SERVICE INSTRUCTIONS

No. 0603-394
ATA Code 34-10

SUBJECT: INSTRUMENTS - PITOT AND STATIC SYSTEM - MODIFICATION OF STATIC AIR SYSTEM TO REDUCE MOISTURE ACCUMULATION

Figure 1. Static Air Button Installation

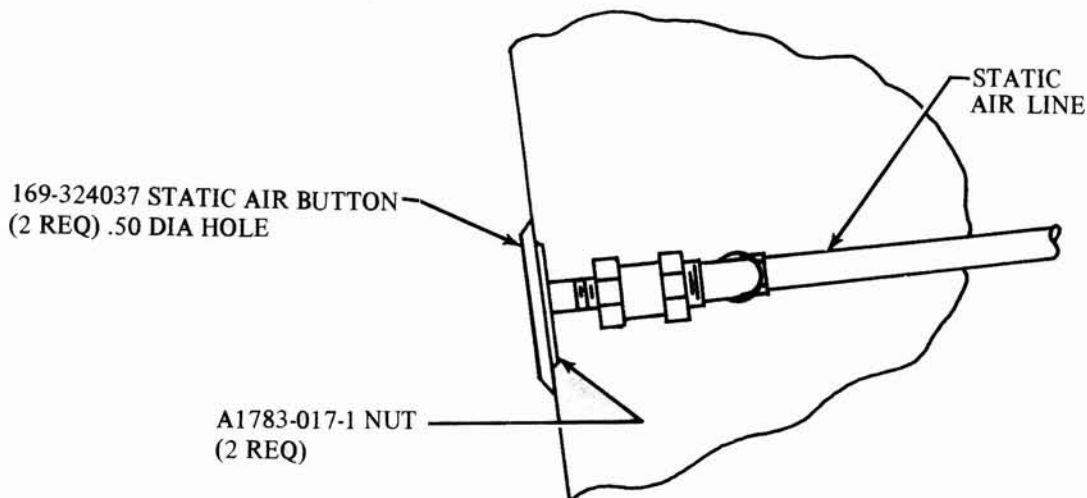
Existing static air buttons are to be removed and replaced with improved static air buttons having three holes angled into the body to reduce the possibility of moisture entering the system. The existing static lines from the buttons to the tee, and the tee are to be removed and replaced with parts having a larger inside diameter.

1. Remove the aft bulkhead panel in the baggage compartment to gain access to the tail of the aircraft.
2. Disconnect the static lines from the static buttons and remove and discard the static buttons from the aircraft.

3. Remove and discard the two tubing clamps and clips from the static lines.
4. Remove the two static lines and the tee from the aircraft.
5. Ream the static button holes in the fuselage skin to .50-inch in diameter. Deburr and prime the bare metal around the holes as necessary.
6. Install the new P/N 169-324037 static air buttons as shown in Figure 1.
7. Install the new P/N 169-580001-281 tubes, P/N 103B 1/8X1/8 elbows and P/N 279P 3/8X1/4 reducing tee as shown in Figure 2. The securing clamps which were removed in step 3 are to be omitted.
8. Reinstall the aft bulkhead panel.
9. Perform a static system check in accordance with FAA Manual AC43.13-1A.

Figure 2. Modification of Static Air System.

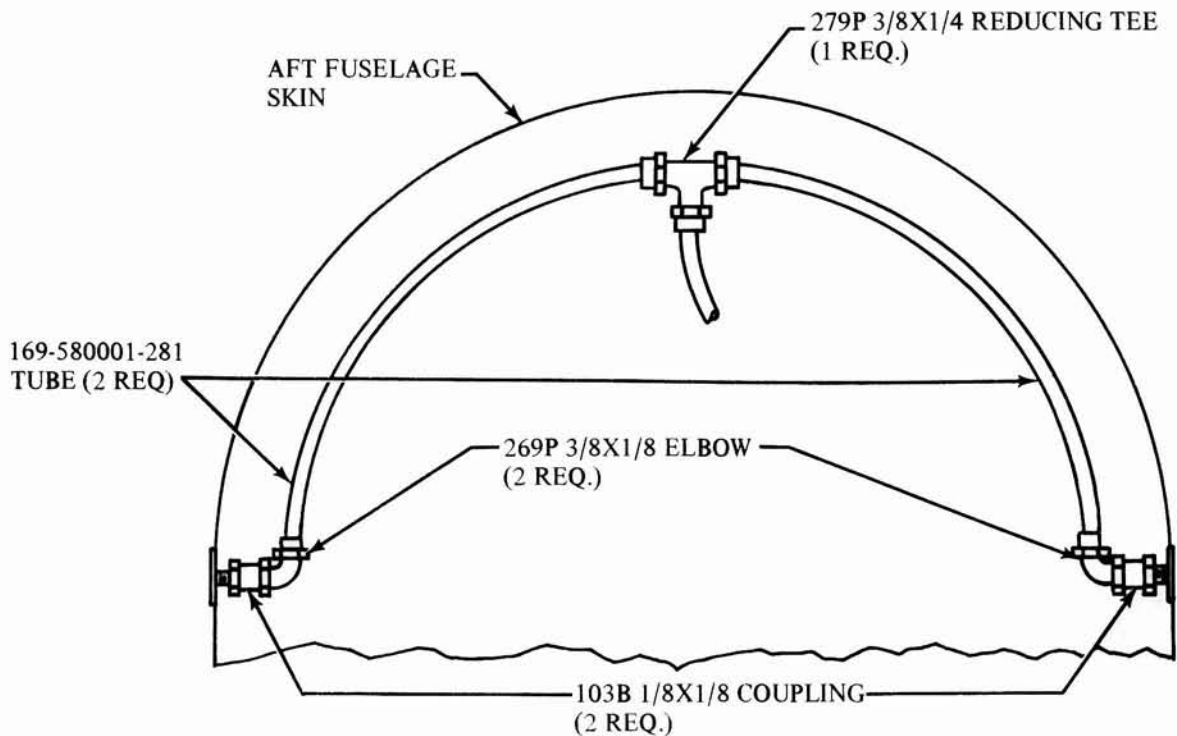
Existing static lines from the static air buttons to the tee, and the tee are to be removed and replaced with parts having a larger inside diameter.

1. Remove the aft bulkhead panel in the baggage compartment.
2. Disconnect the two static lines from the static buttons and discard the attaching fittings.
3. Remove and discard the two tubing clamps and clips from the static lines.
4. Remove and discard the two static lines and the tee.
5. Install the new P/N 169-580001-281 tubes, P/N 103B 1/8X1/8 couplings, P/N 269P 3/8X1/8 elbows and P/N 279P 3/8X1/4 tee as shown in Figure 2. The securing clamps which were removed in step 3 are to be omitted.
6. Reinstall the aft bulkhead panel.
7. Perform a static system check in accordance with FAA Manual AC43.13-1A.
